APPLICATION FOR AMENDMENT TO
OPERATING LICENSE

Indian Point Unit No. 2
Docket No. 50-247

Facility Operating License, No. DPR-26

SAFETY EVALUATION

Figure 3.10-2

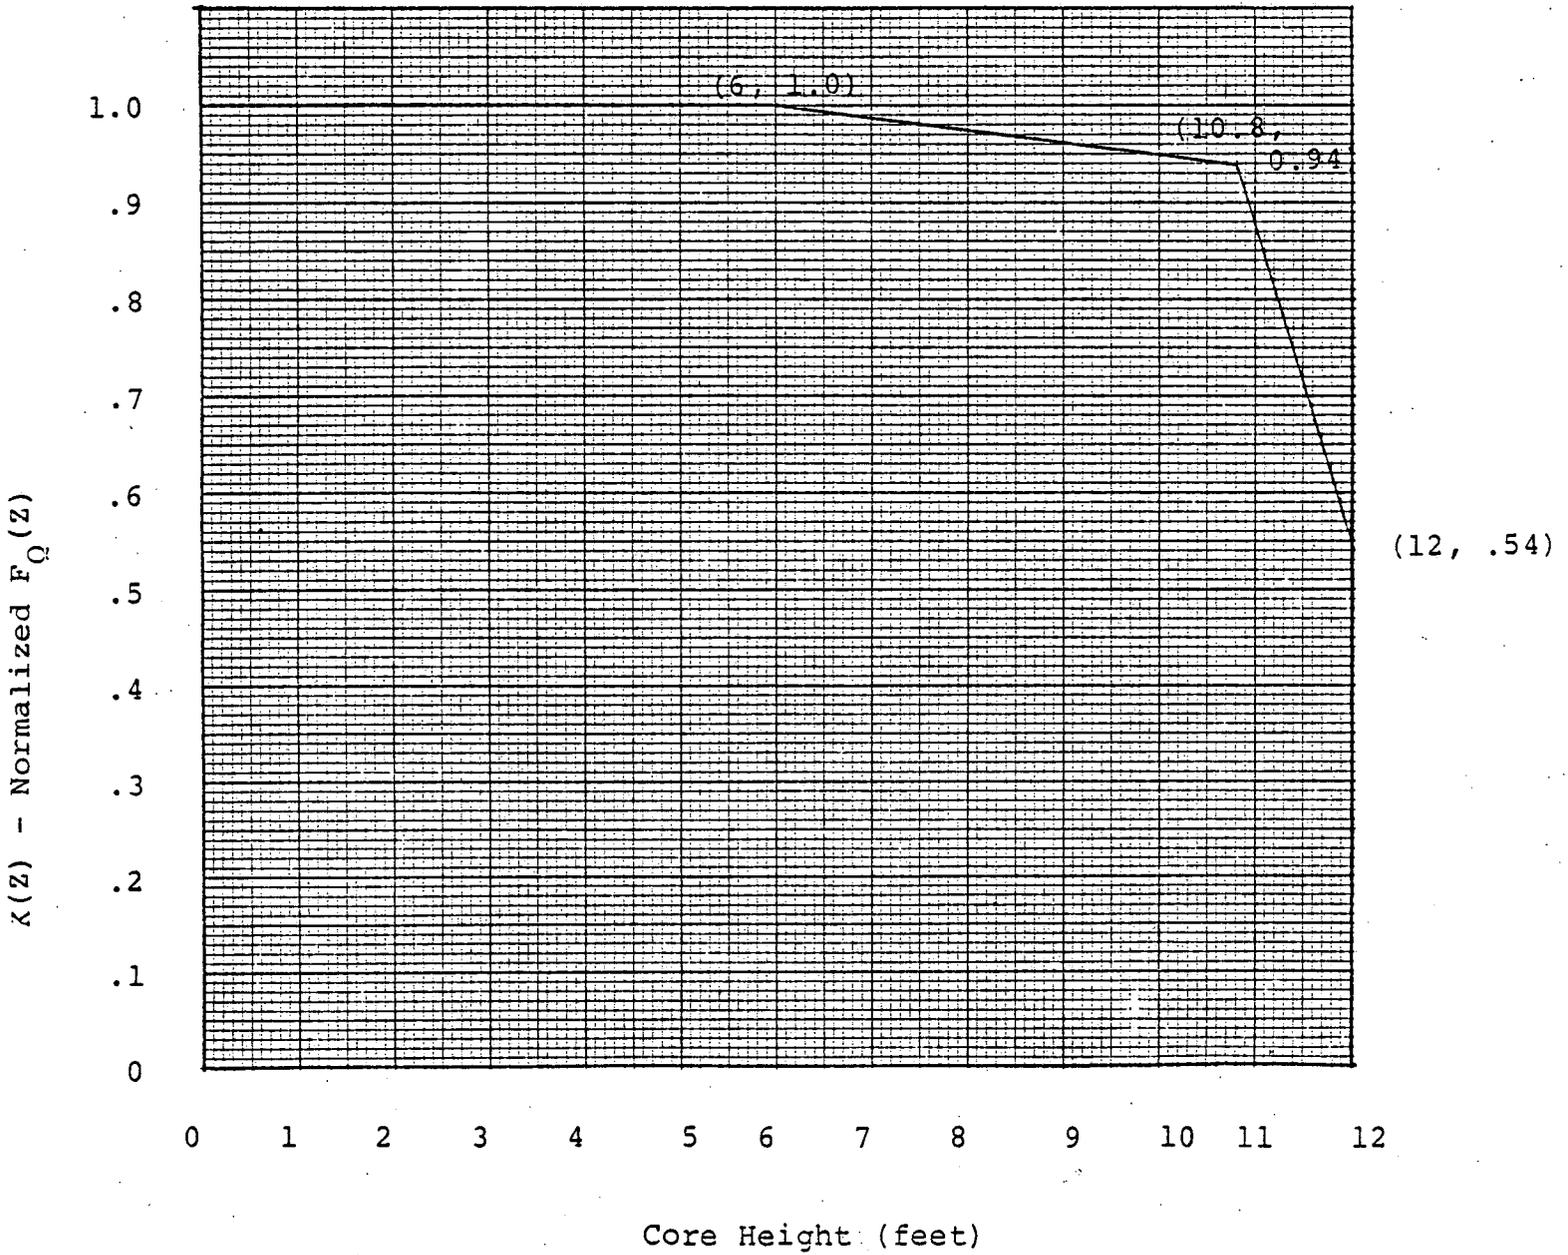
The proposed change to the three figures in Section 3.10 of the Technical Specifications and to the proposed Sections 3.10 of the Applications for Amendment to the License filed on September 6, 1974 and July 9, 1975 would make these figures consistent with the conclusions stated in the Reload Safety Evaluation for Indian Point Nuclear Plant Unit 2, Cycle 2. This Reload Safety Evaluation re-examines power capabilities and accident evaluations for Indian Point Unit No. 2. It is concluded in this Reload Safety Evaluation that the proposed Cycle 2 core reload and these proposed changes to the three figures in Section 3.10 of the Technical Specifications will not adversely affect the ability to safely operate at 100% of rated power during Cycle 2 and that the applicable design bases limits for the postulated incidents analyzed in the FSAR are not exceeded.
